TO: Mercedes-Benz Dealer Principals, General Managers, Sales Managers, Service Managers, Parts Managers	FROM: Gregory Gunther, Department Manager, Vehicle Compliance and Analysis, Engineering Services
RE: <b>Emission Service Campaign 2021050013 Launch Notification</b> <b>Replace Emission Control Information Label MY19 (E-Class, CLS-Class)</b>	DATE: August, 13 2021

Campaign No. 2021050013, August 2021

## **Replace Emission Control Information Label**

Figure 1

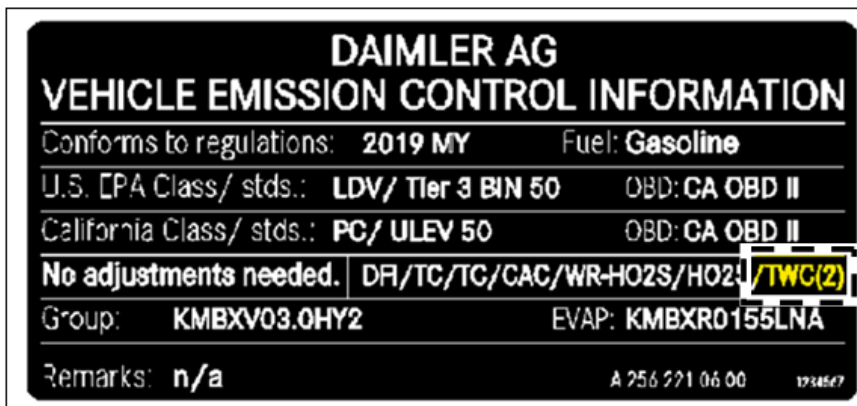
1. Open hood.
2. Replace the Emission Control Information label (**Figure 1**) on hood.
  - i** The new label must contain the text "**TWC(2)**" (**Figure 1**)!
  - i** For model 213 - bonding position 3.3, (**Figure 2**).
  - i** For model 238 - bonding position 3.3, (**Figure 3**).
  - i** For model 257 - bonding position 3.1, (**Figure 4**).
  - i** Remove old label by using a heat gun.
  - i** Contamination and adhesive residues from the old label must be removed via a thorough cleaning.
